Sydney Metro Martin Place

North Tower Base Building Changes

SSD/ MOD drawings & FC2 Comparison

Rev #02 – 26/10/21

Level 18 Plan

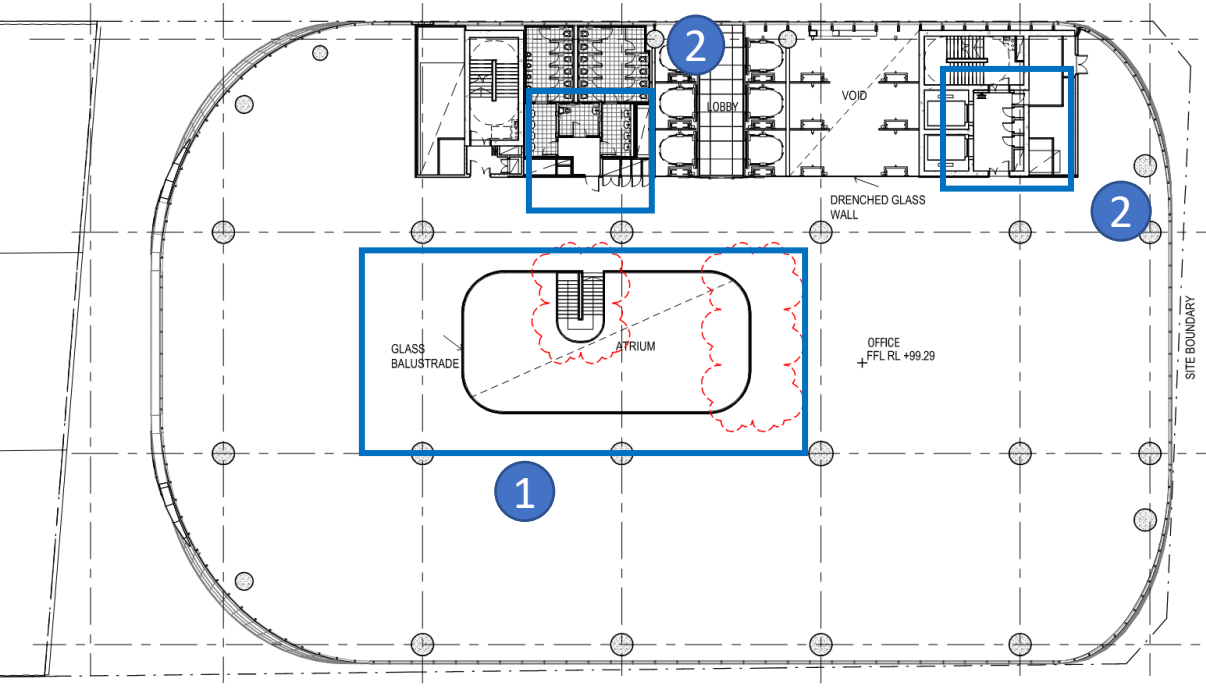
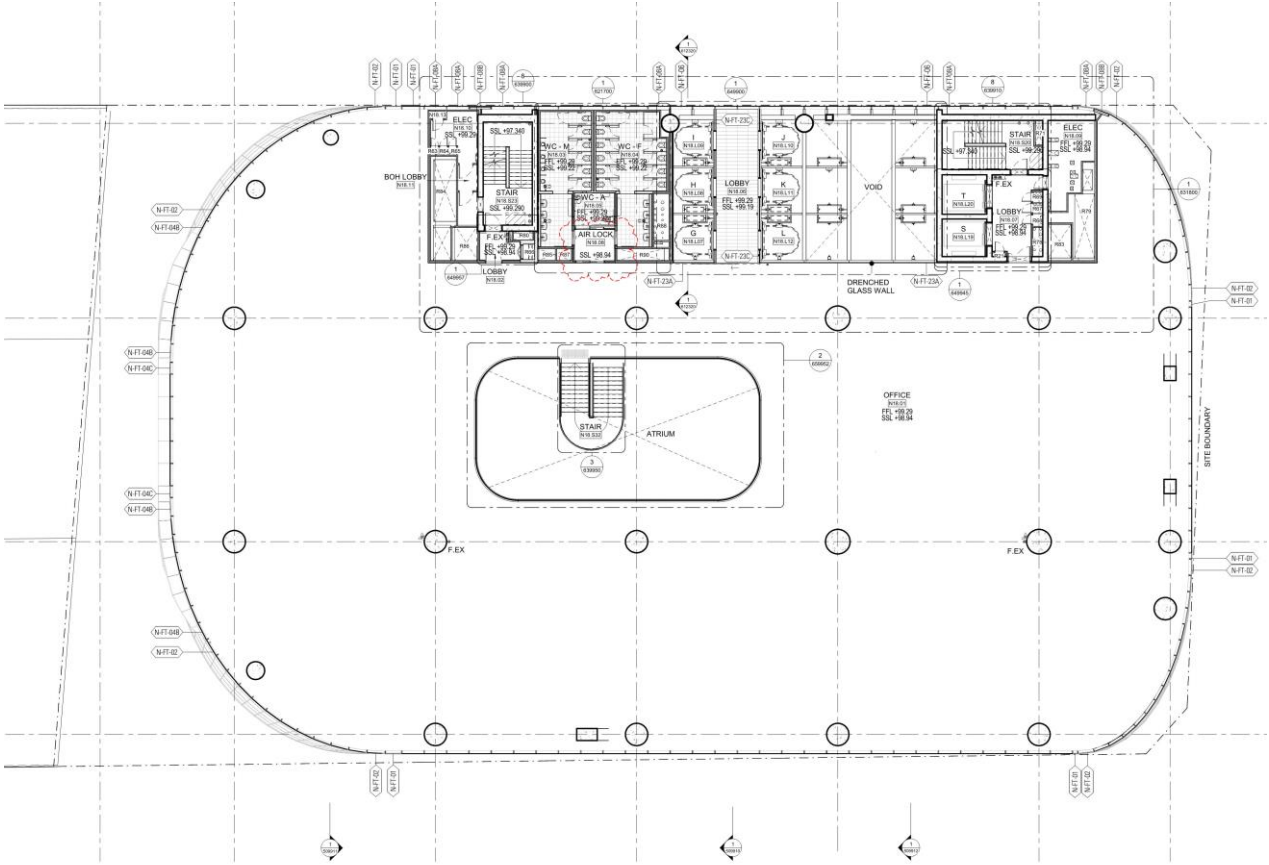
- 1.Atrium and stair revised
- 2.BOH layout revised

Level 19 Plan

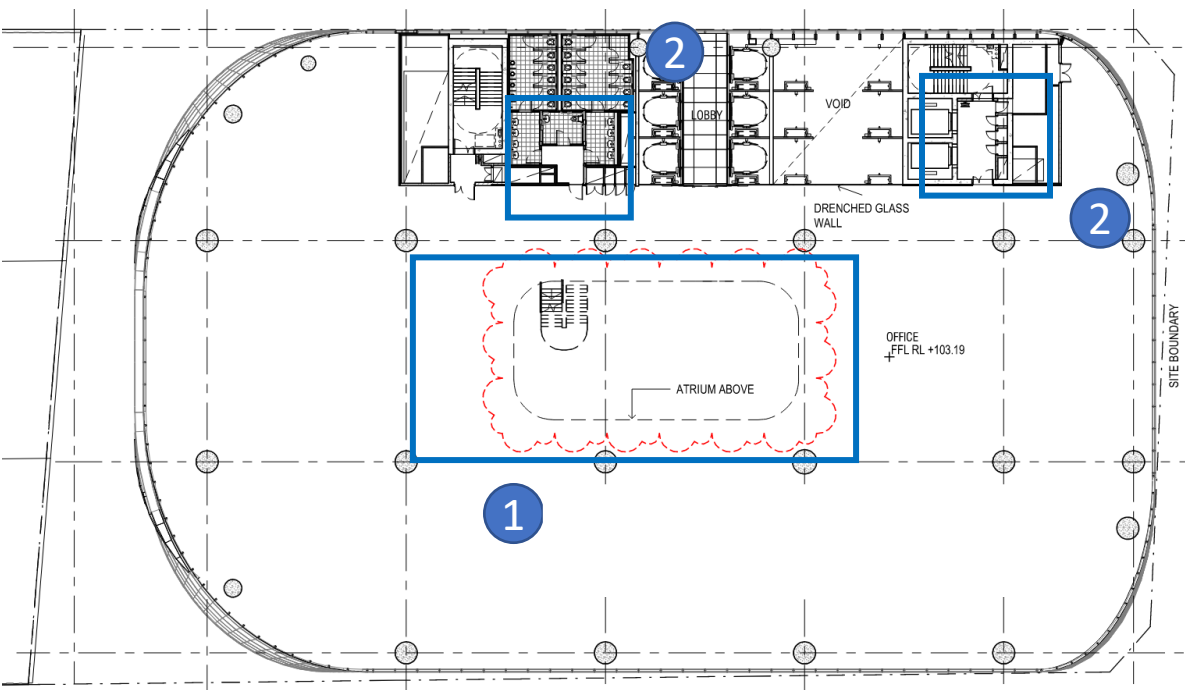
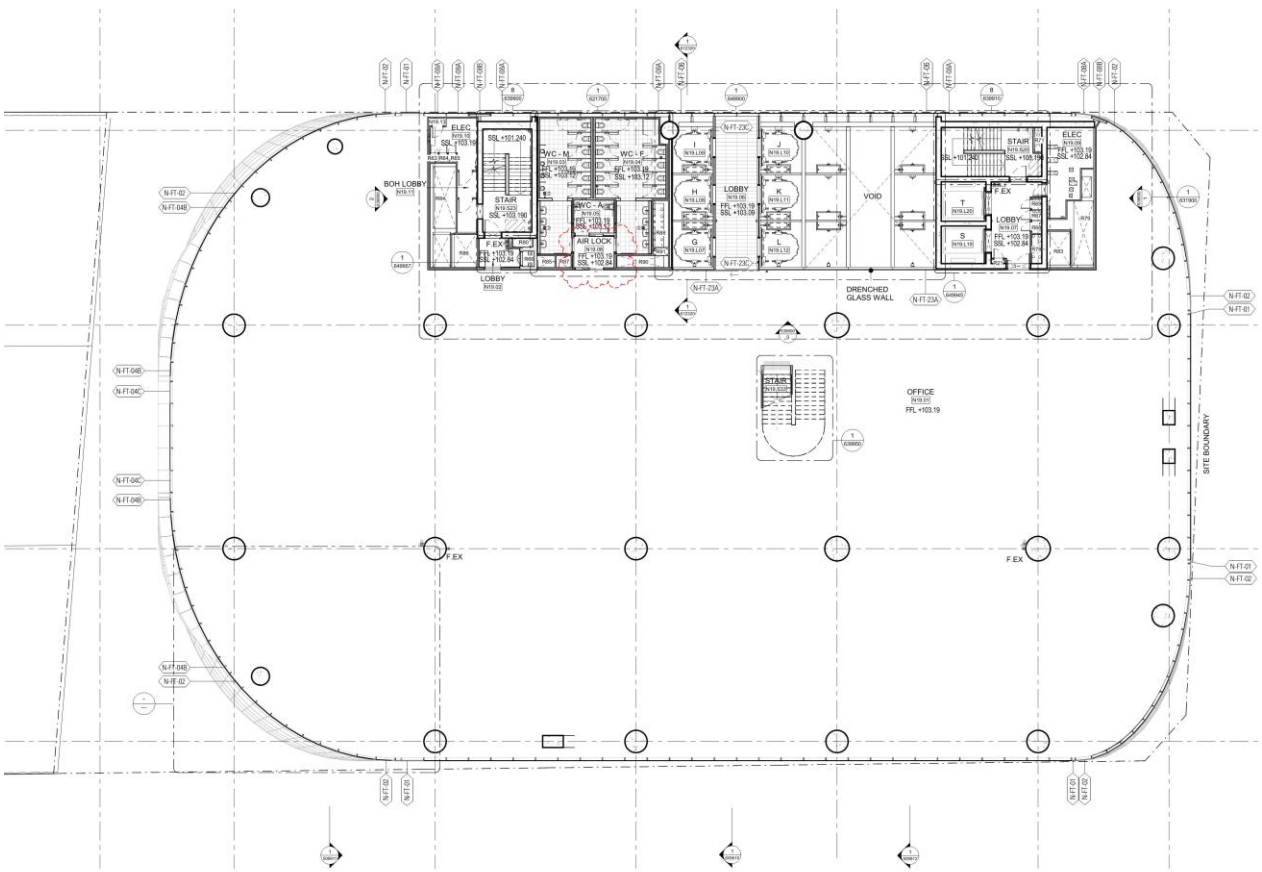
- 1.Atrium and stair revised
- 2.BOH layout revised

Level 20 Plan

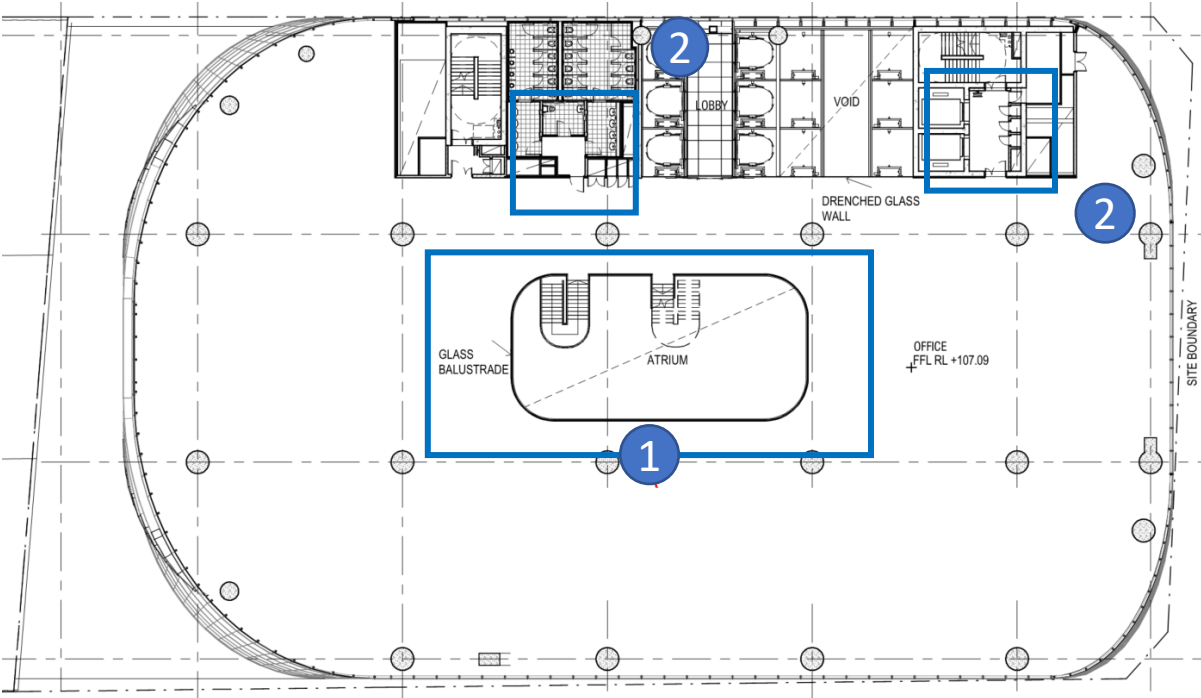
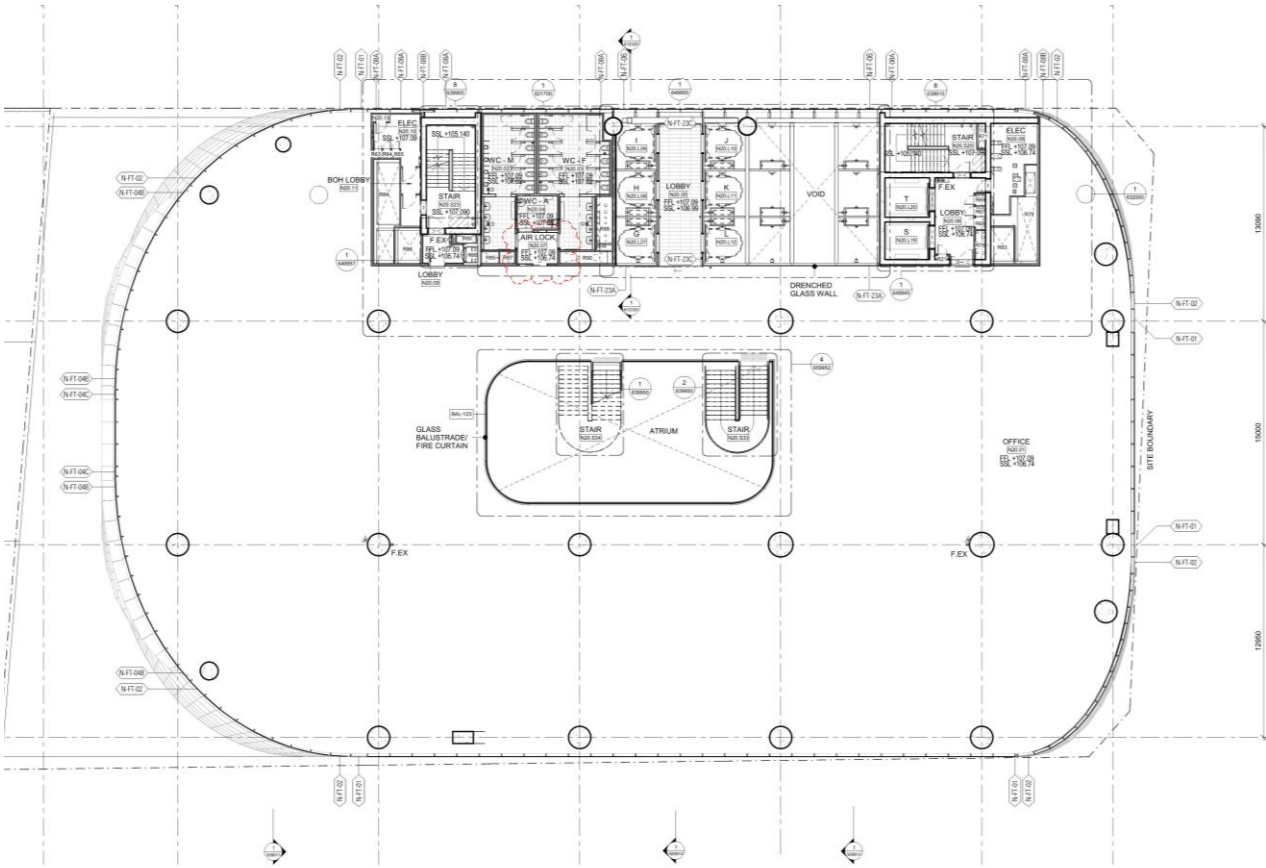
- 1.Atrium and stair revised
- 2.BOH layout revised

Level 21 Plan

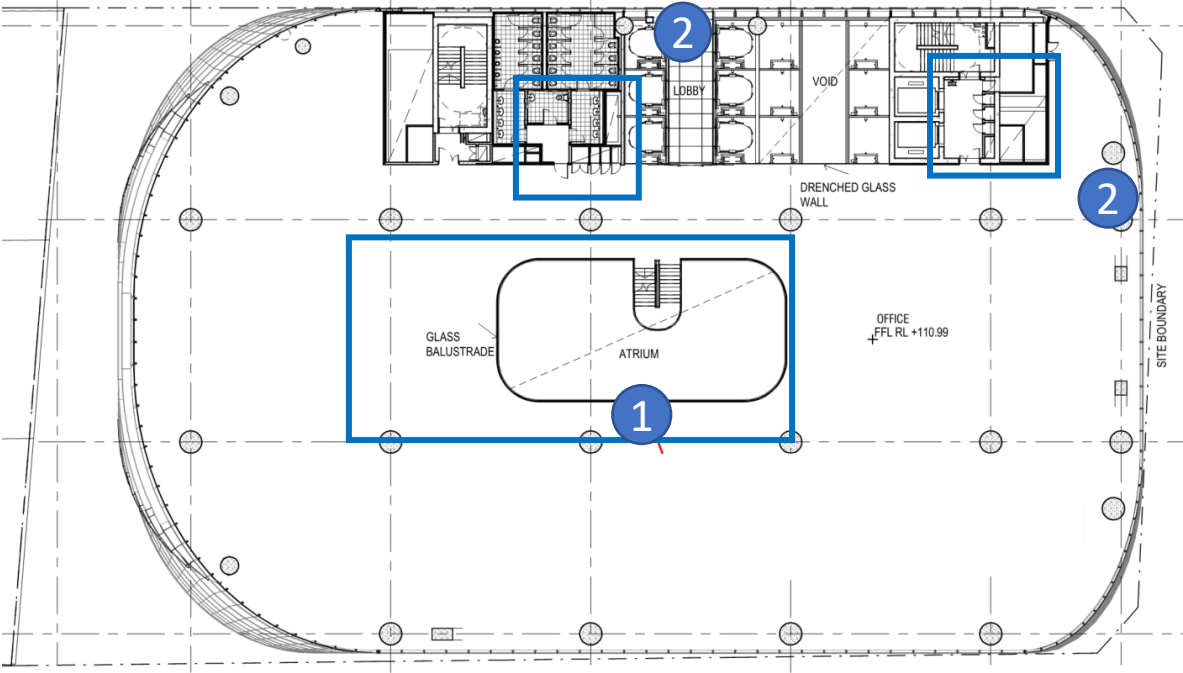
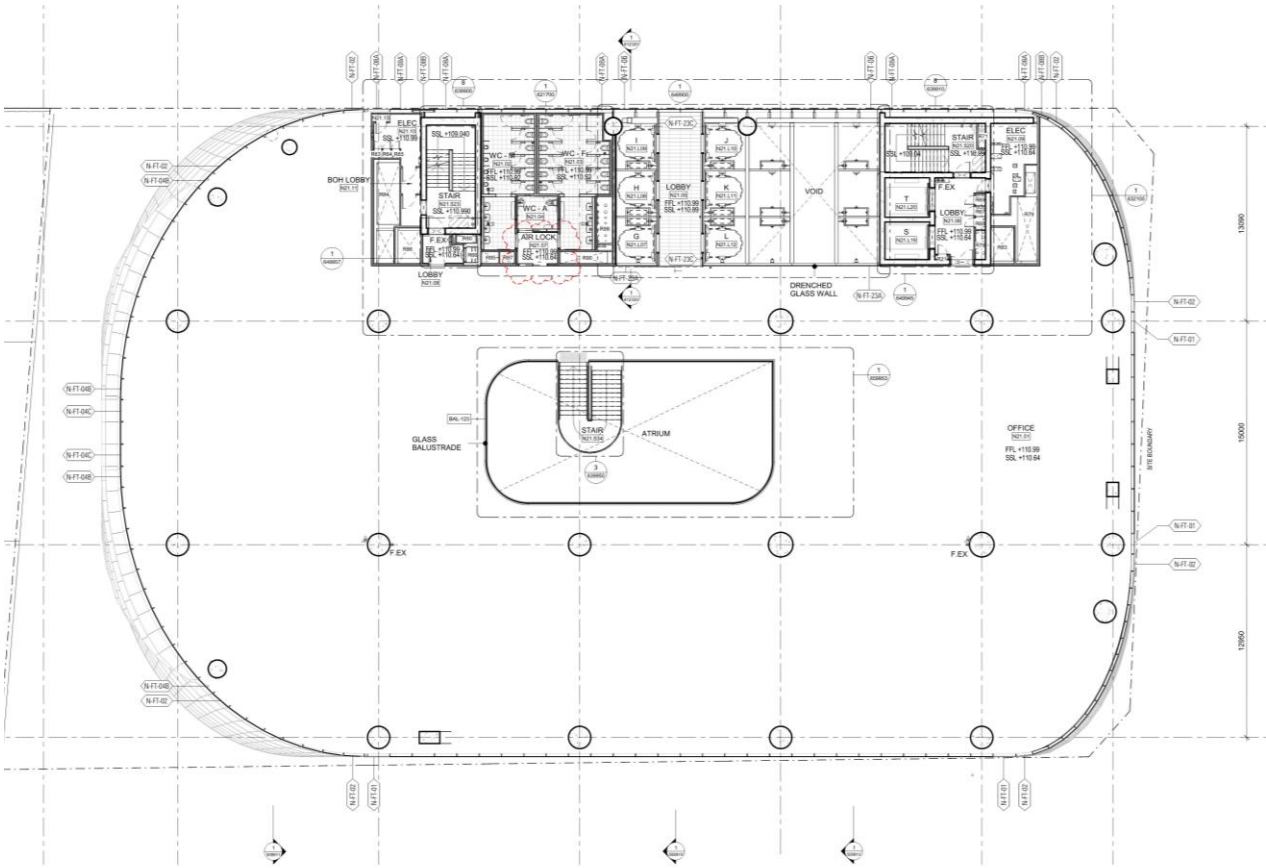
- 1.Atrium and stair revised
- 2.BOH layout revised

Level 22 Plan

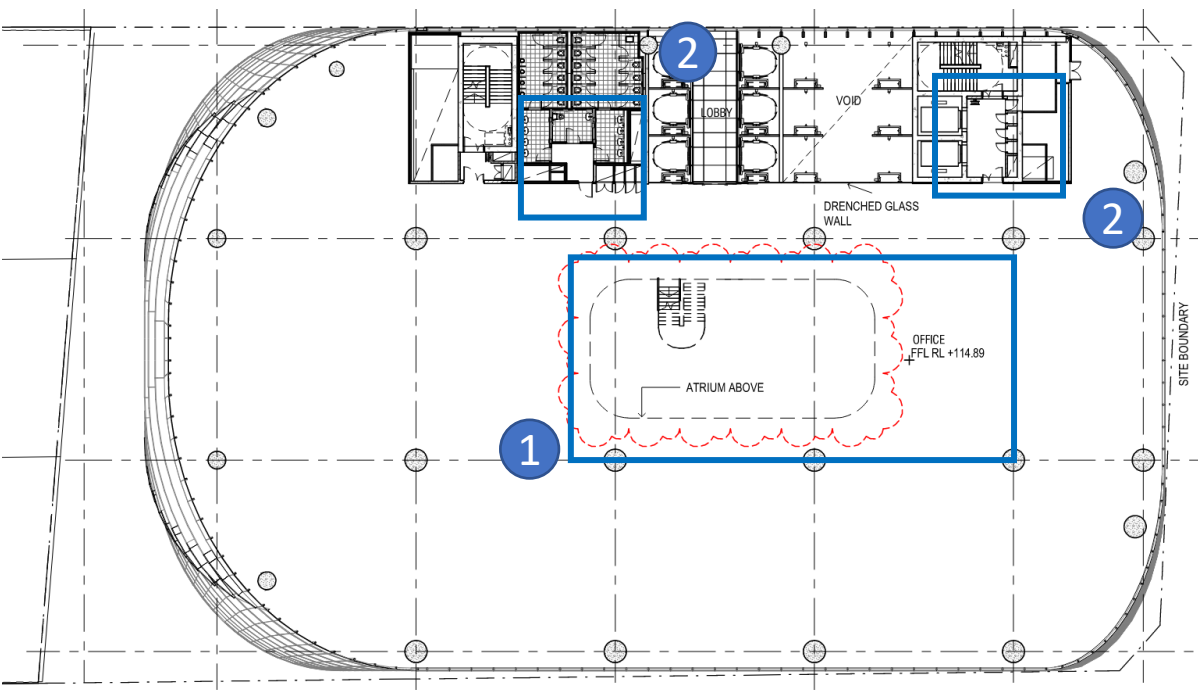
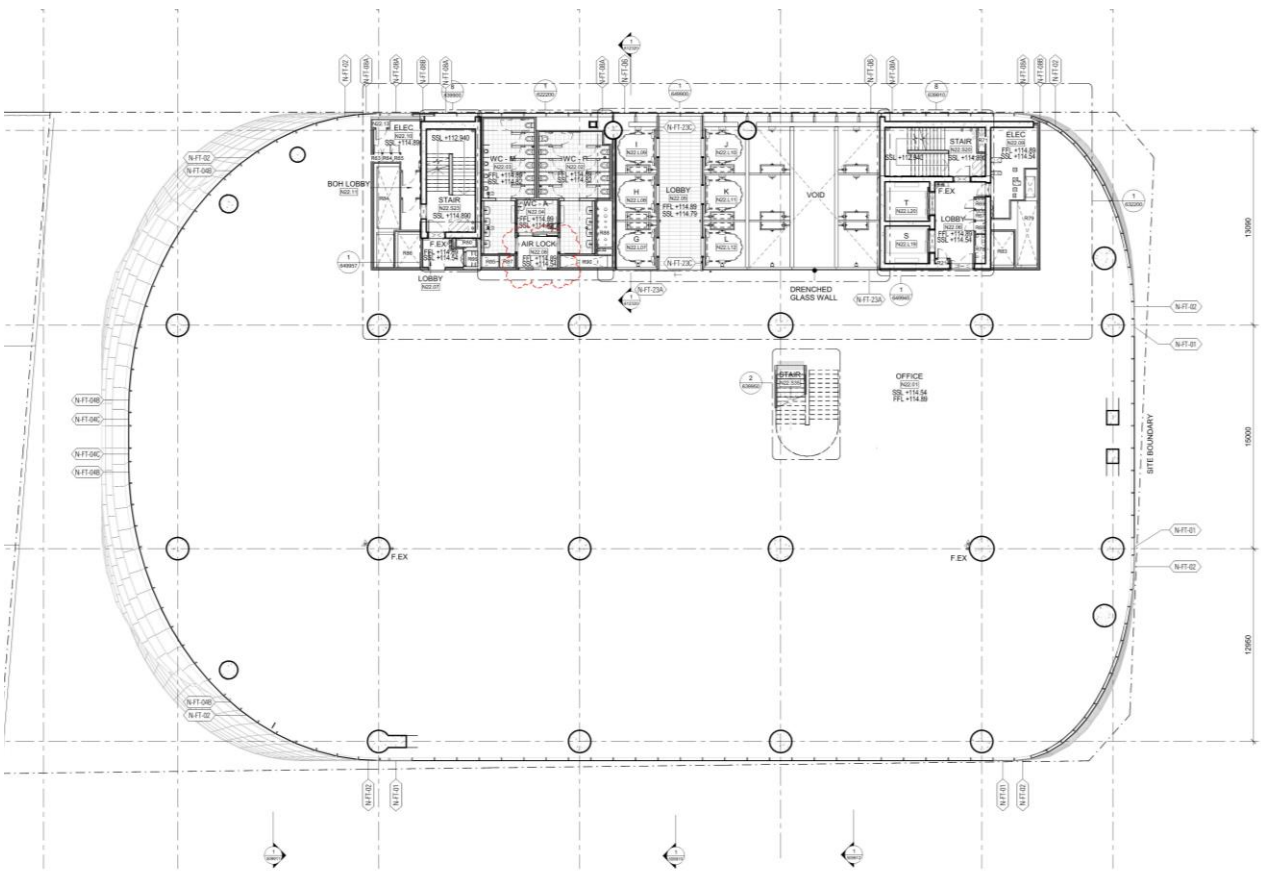
- 1.Atrium and stair revised
- 2.BOH layout revised

Level 23 Plan

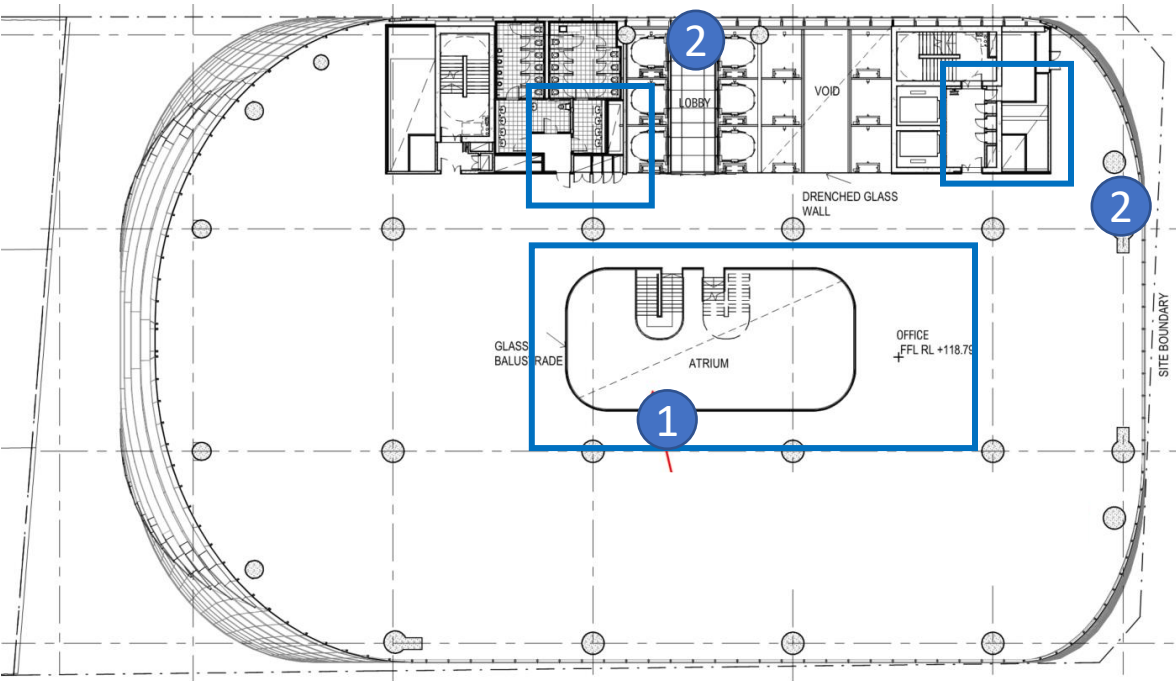
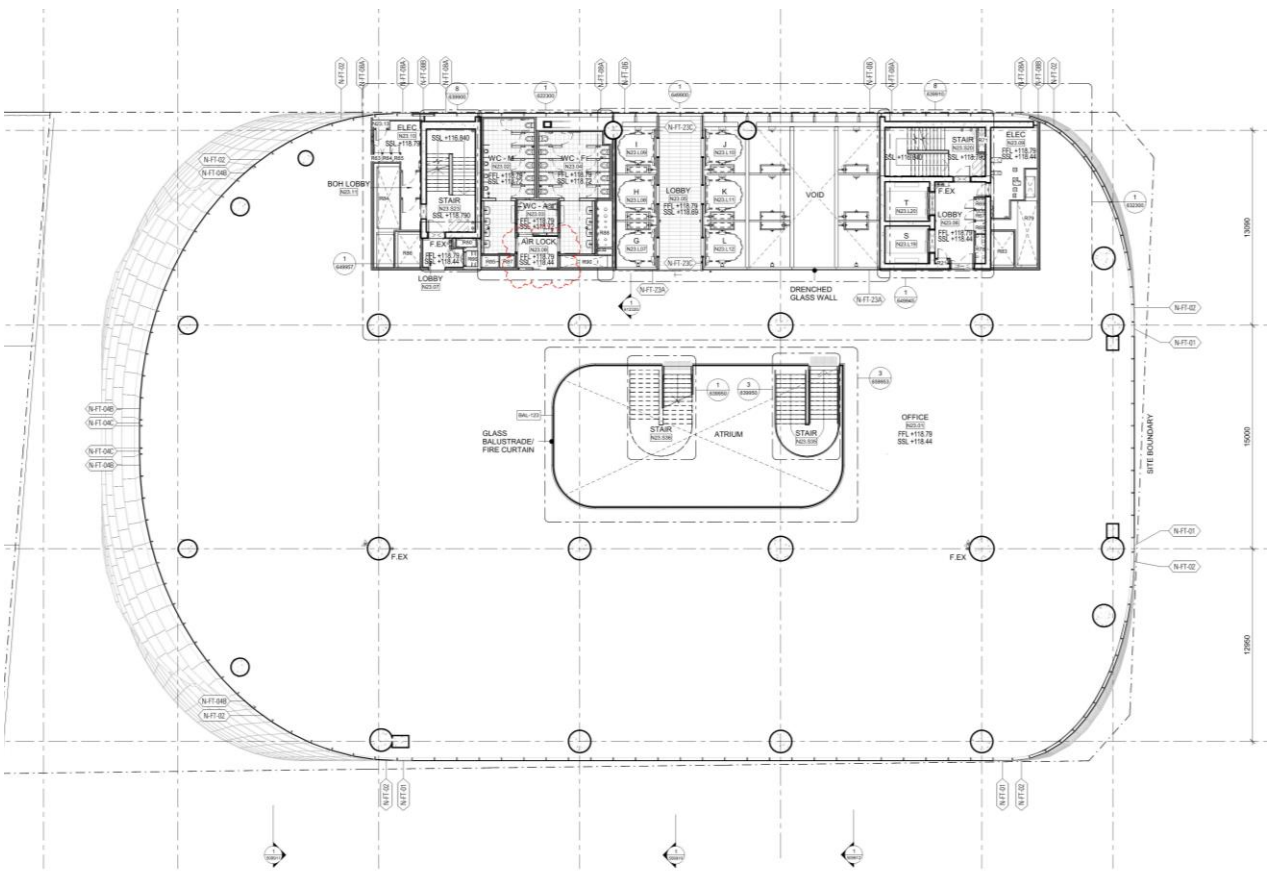
- 1.Atrium and stair revised
- 2.BOH layout revised
